ADDENDUM #3 – REVISIONS TO THE CONTRACT DOCUMENTS

Grand Junction VA Medical Center PM&RS and Prosthetics Center

Item 1: Change to 01 00 00 General Requirements

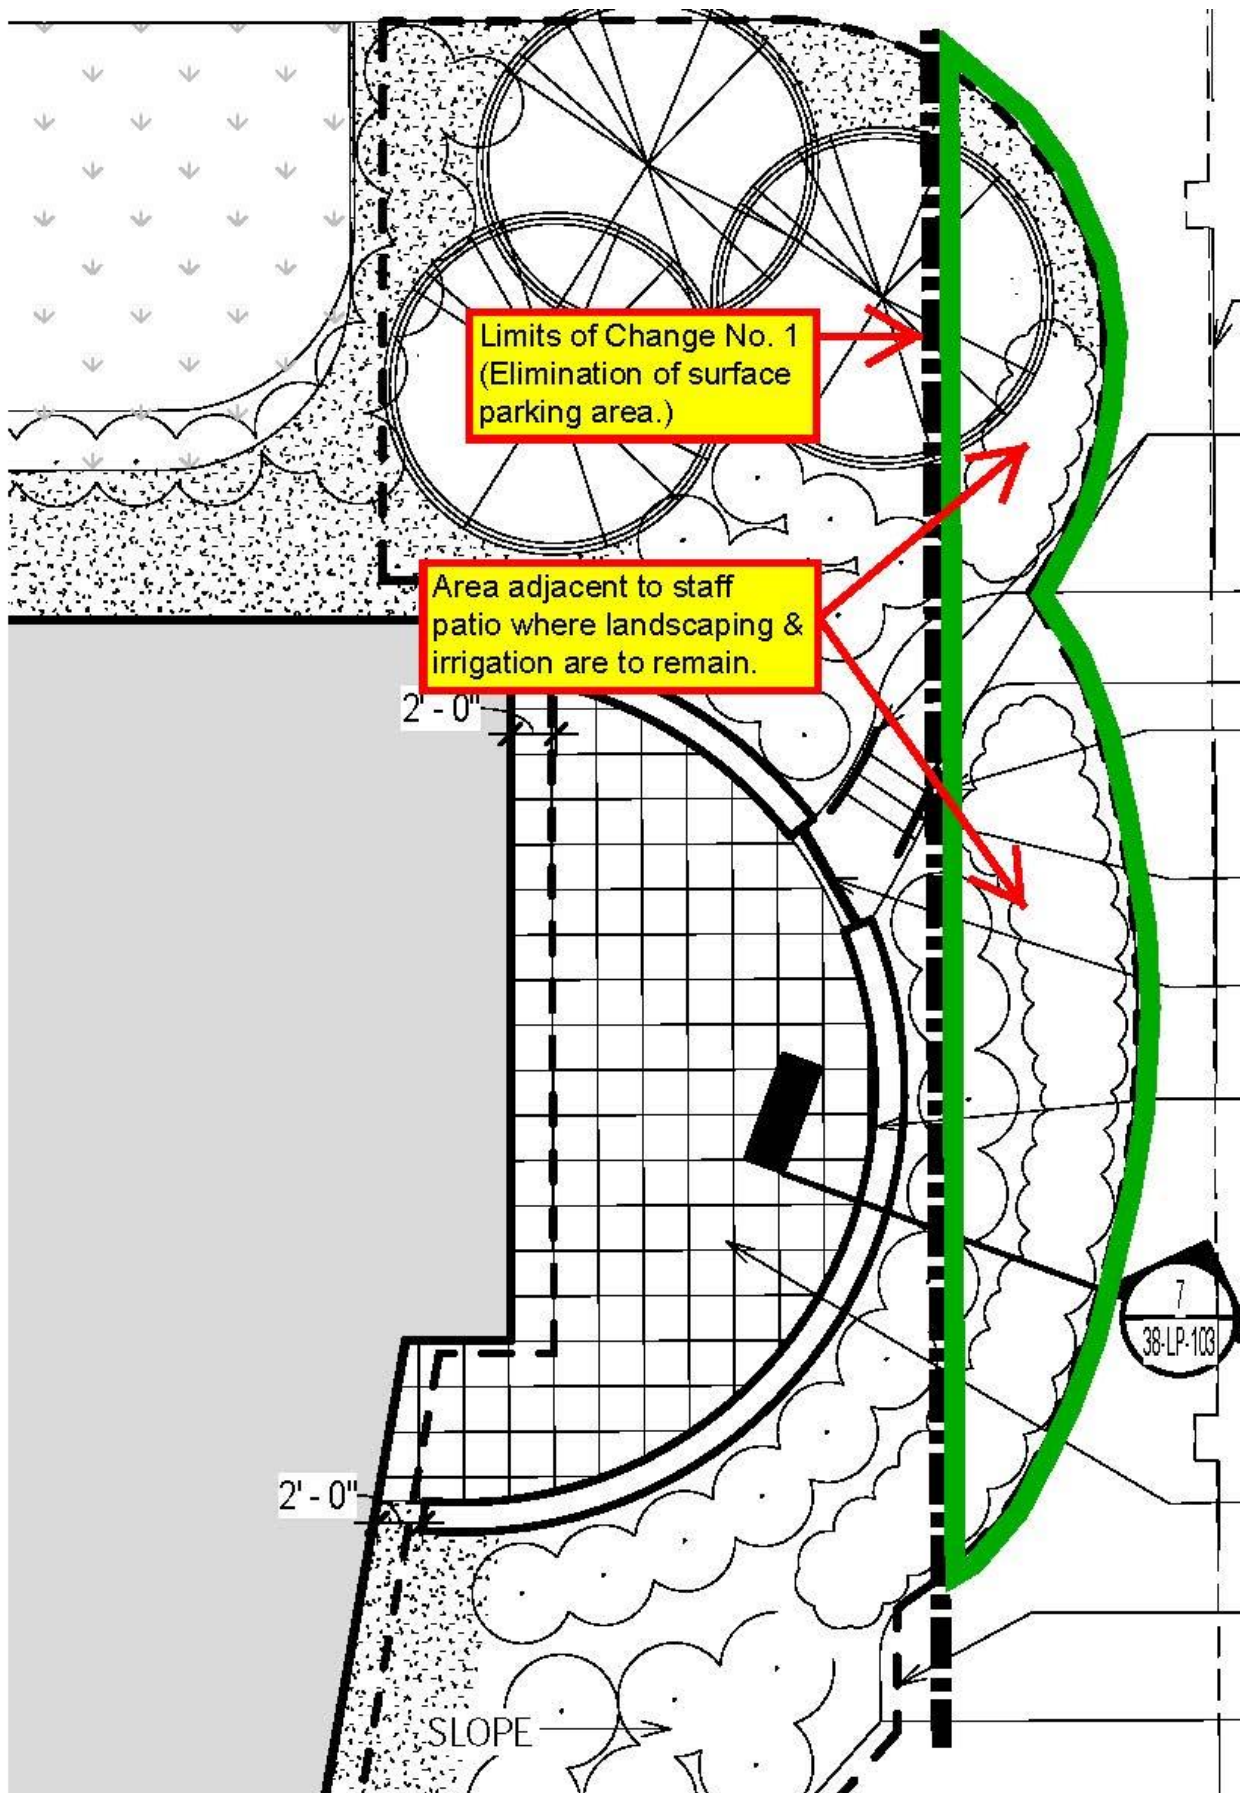
ALL LANDSCAPING AND ASSOCIATED IRRIGATION (PER SPECIFICATION 32 84 00) WITHIN THE CONSTRUCTION LIMITS OF CHANGE NO. 1, ADJACENT TO THE STAFF PATIO, AS SHOWN ON SHEET 38-LP-102, DETAIL 2 – ENLARGED STAFF PATIO PLAN, ARE TO BE INCLUDED IN CLIN 0001 AS A PART OF THE PROJECT.

For clarification, see the following sketch identifying landscaping adjacent to the staff patio that is to remain and be included in CLIN 0001.
